THE PRINCE GEORGE'S COUNTY GOVERNMENT

Re: Municipal Storm Drain
Acceptance Program
Town of University Park

MUNICIPAL STORM DRAIN ACCEPTANCE PROGRAM

MAINTENANCE REPORT

SUBDIVISION NAME *University Park*
STREET: *Wells Parkway (1 of 3)*
200' SHEET NUMBER: *209 NE 3* *208 NE 3*

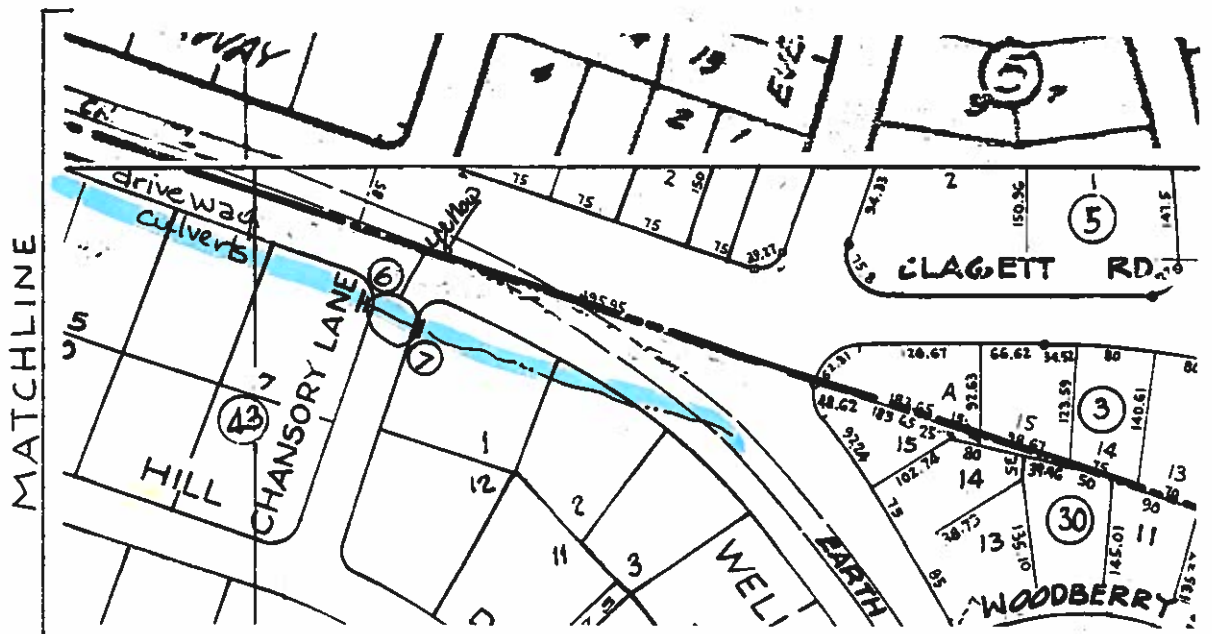
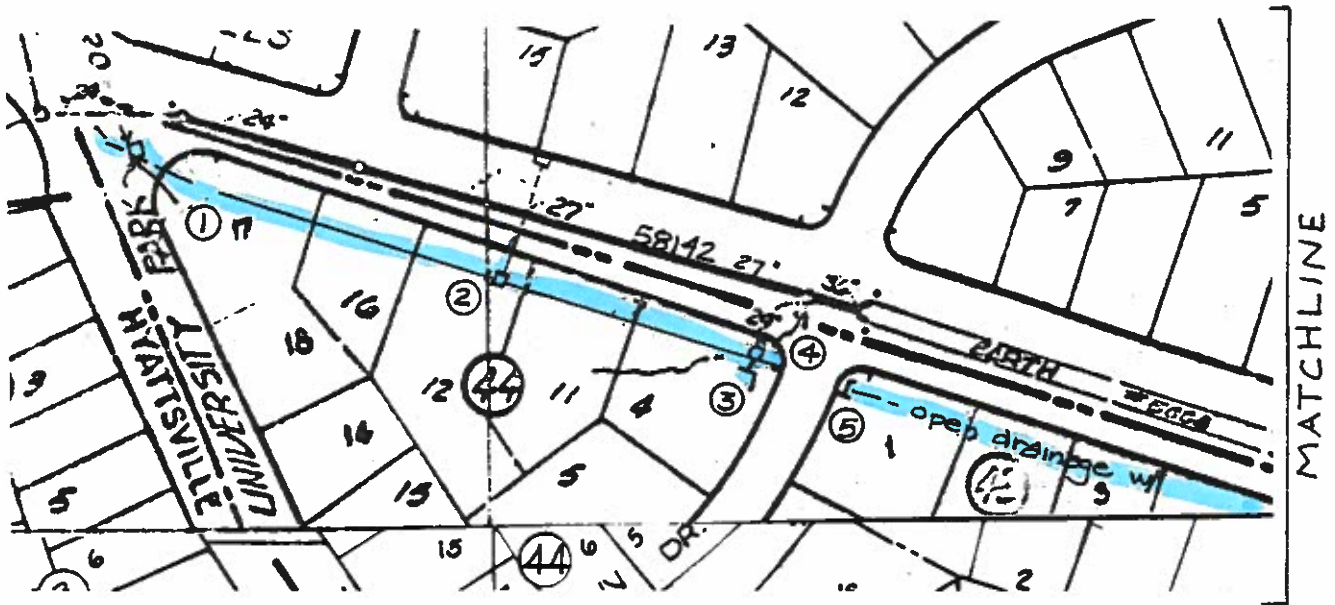
NUMBER	TYPE	PROBLEM	LOCATION
<i>1</i>	<i>B manhole with D top in grassy area</i>	<i>see footnote</i>	<i>Wells PKwy</i>
<i>2</i>	<i>B manhole with D top on lot</i>	<i>see footnote</i>	<i>Wells PKwy</i>
<i>3,6</i>	<i>head wall</i>	<i>see footnote</i>	<i>Wells PKwy</i>
<i>4</i>	<i>manhole</i>	<i>see footnote</i>	<i>Wells PKwy</i>
<i>5,7</i>	<i>endwall</i>	<i>see footnote</i>	<i>Wells PKwy</i>

Footnote: Field investigation indicates system is located on private lots, most probably within 10' Public Utility Easement, not in the roadway as shown on the 200'sheet.

Recommendation: Accept entire system for maintenance provided system is located in public easement. The county will not accept the private driveway culverts crossing the open channel for lot access. Maintenance of the earthen channel will be limited to channel stability and adequate conveyance of stormwater. Aesthetic maintenance including mowing will be performed by individual lot owners or the Town of University Park. If the open drainage is located on private lots without the necessary easements the county will not maintain the channel.

SUBDIVISION NAME *University Park*
STREET: *40th Ave, Adelphi Rd. (1 of 3)*
200' SHEET NUMBER: *208 NE 3*

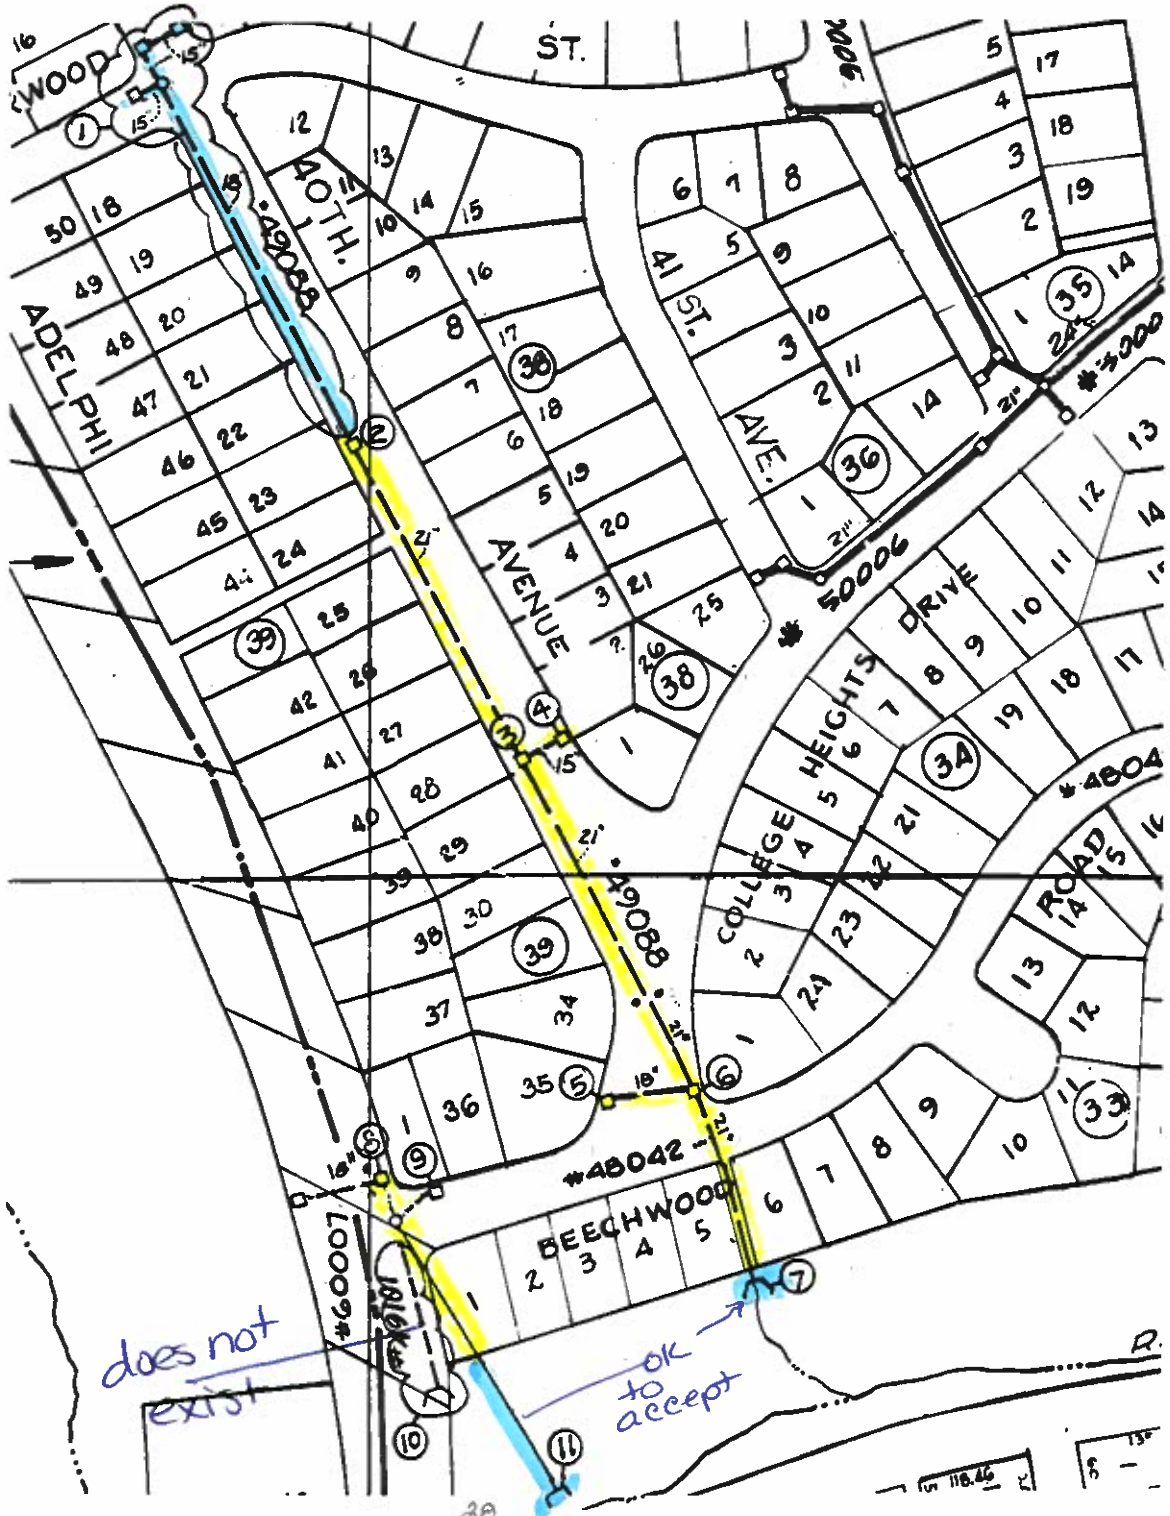
NUMBER	TYPE	PROBLEM	LOCATION			
1	Storm drain system	doesn't exist	40 th Ave			
	enclosed in 	upon field inspection				
2 3 4 5 6	curb inlets	no problem	40 th Ave			
7				outfall	no endwall; Town has modified to repair a pipe break pipe is exposed.	Park prop. (Toledo Rd.)
8 9				curb inlets	no problem	Adelphi and Beechwood Rds.
10				storm drain system	not properly located on 200' sheet	Park prop. (Toledo Rd.)
11				endwall	no problem	Park property (Toledo Rd.)

Recommendation: Accept entire system as shown except for outfalls 11 and 7. The outfalls are on parkland owned by the Town of University Park and lack the necessary easements for maintenance.

SUBDIVISION NAME *University Park*
 STREET: *Route 1 at Beechwood Rd.*
 200' SHEET NUMBER: *208 NE4*

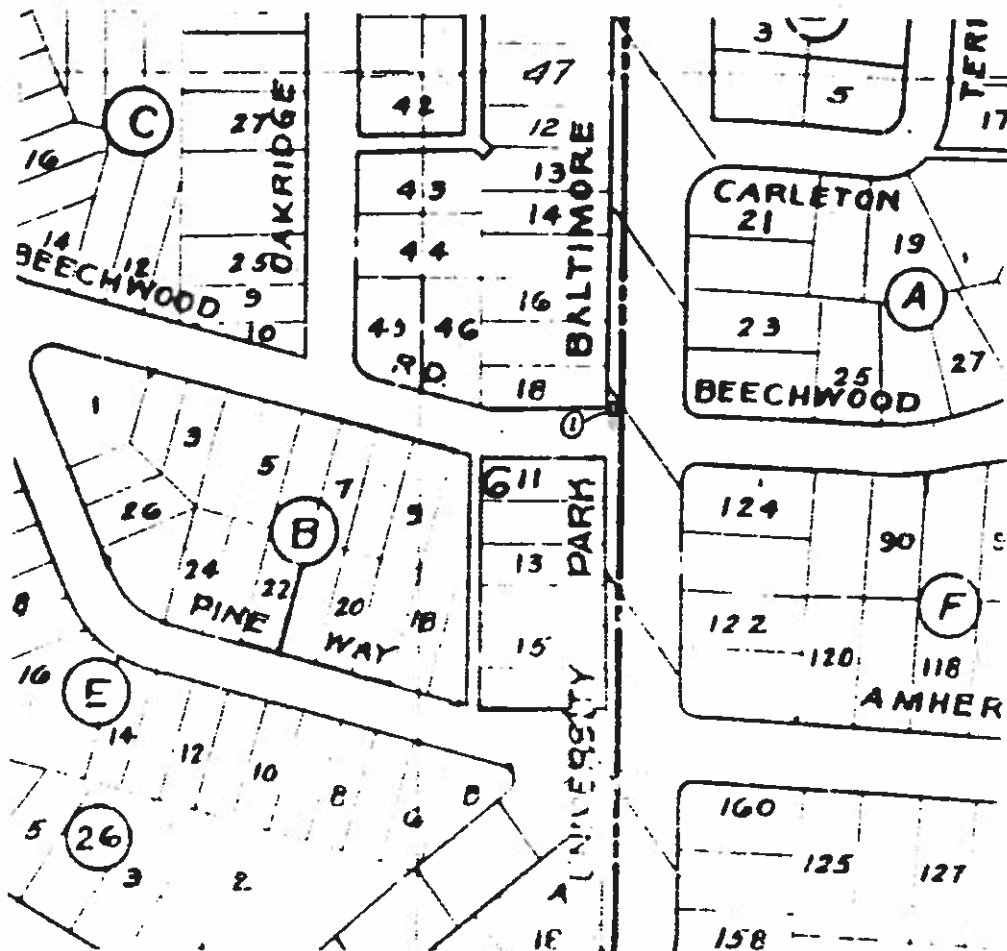
NUMBER	TYPE	PROBLEM	LOCATION
1	grate inlet	SHA R/W	Rt 1 at Beechwood Rd.

Recommendation: Inlet located in State R/W and will be maintained by the State of Maryland.

SUBDIVISION NAME *University Park*
 STREET: *Route 410, Queen's Chapel Rd.*
 200' SHEET NUMBER: *207 NE 3*

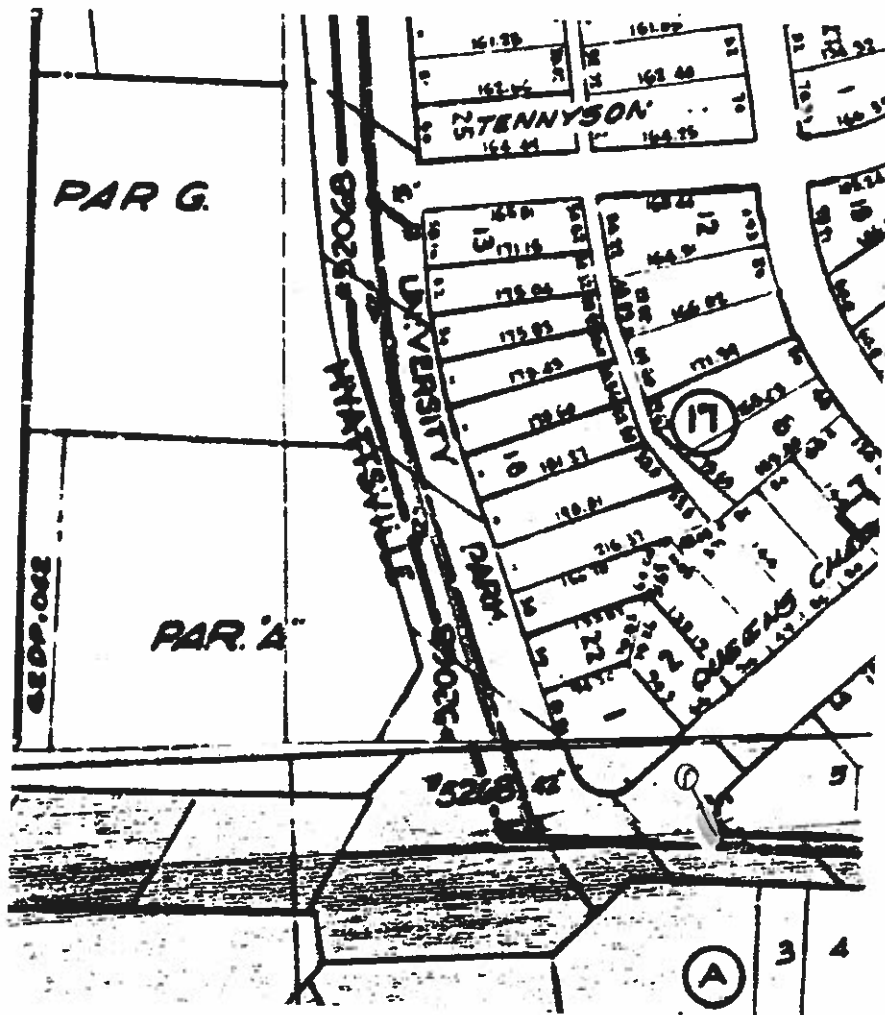
NUMBER	TYPE	PROBLEM	LOCATION
<i>1</i>	<i>WR inlet</i>	<i>located in 410 R/W</i>	<i>Queen's Chapel Rd and Rt. 410</i>

Recommendation: inlet drains 410 (state highway) and will therefor be maintained by the State of Md.
